REQUEST FOR INFORMATION **DATE:** September 27, 2016 **NO.:** RFI-300

Project Name: 15051-Webster University Interdisciplinary Science Building Project No.: 15051

Subject: Clarifications to RFI 292

1 ENLARGED DETAIL @ SSG CURTAINWALL SILL & WA-L2
3" = 1'-0"

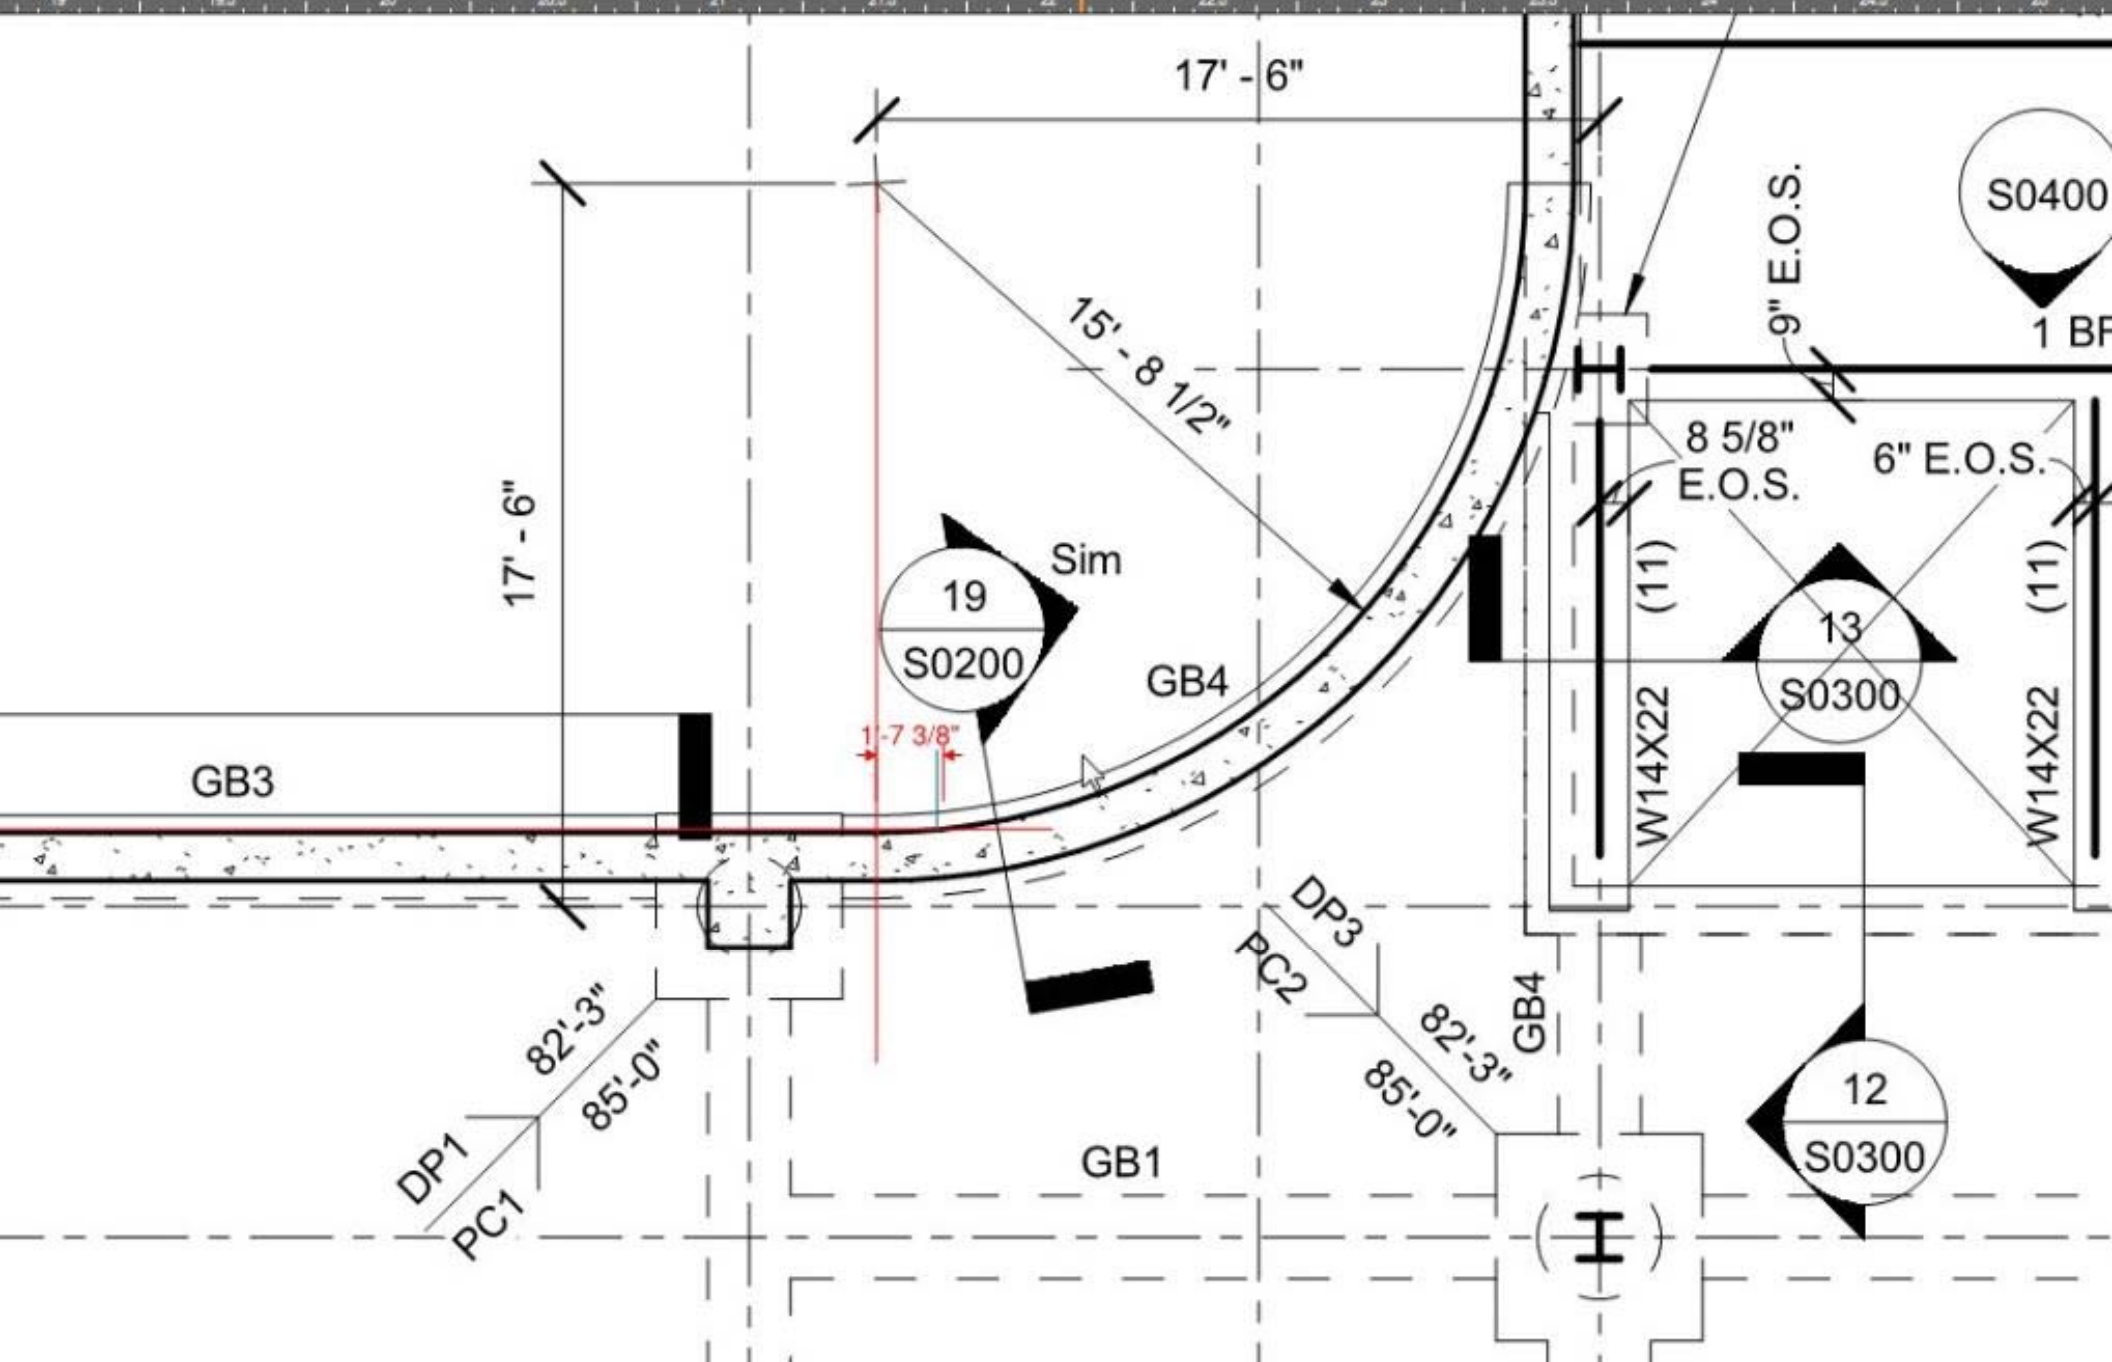
Upon review of RFI 292 it was determined the wall on C.3 line was placed per 11/S200 which gives a dimension of 1' 10 1/2" from C.3 line. The level 0 wall along 5 line was placed per 1/S300 and once the wall for level 01 is placed it will have a dimension of 1' 9 1/2" from 5 line. This conflicts with the RFI 292 response that both C.3 and 5 line should have a dimension of 1' 9 1/2" from CL line.

1. Please confirm starting the radius at 15' 10 5/8" west of 5 line per conversation with Devin Gates, Lynn Grossman, and Kelvin Patel is acceptable.
2. The cascadia clips are available in 2 1/2" lengths in lieu of 3 1/2" as identified on A400, please confirm these and the reduced insulation are acceptable to the design team.
3. If 2 1/2" cascadia clips are allowable, please confirm how contractor should transition from 3 1/2" to 2 1/2" at radius.

1. See clarification below by Lynn Grossman via email to Paric (Devin Gates) on 09.27.2016 - "Center point of radius remains the same. Radius remains the same. Radiused wall stays in same place as shown on drawings. Face of wall parallel to C.3 joins radiused wall 1'-7 3/8" east of where it would have previously (because it is 1" north of where shown on the drawings.)".

2 & 3. The 2 1/2" Cascadia clips are not acceptable. They have impact on insulation, curtain wall at windows and steel angle at the head & sill of curtain wall. See attached sketch for possible solution. GC to coordinate the impact of the change with other systems. Submit revised details and/or other proposals for review.

1" is accommodated by reducing the 'Z' by
1/2" and extending the brake metal by 1/2".

Coordinate transition of revised
system with the original system at
the curve.

Edge of the concrete wall will need to be ground so that
the top of brake metal aligns with the top of concrete wall.

Submit revised
details for review.

As discussed with Paric (Devin Gates), this needs
to be coordinated with NGG to ensure the curtain wall
system will work with revised dimensions.
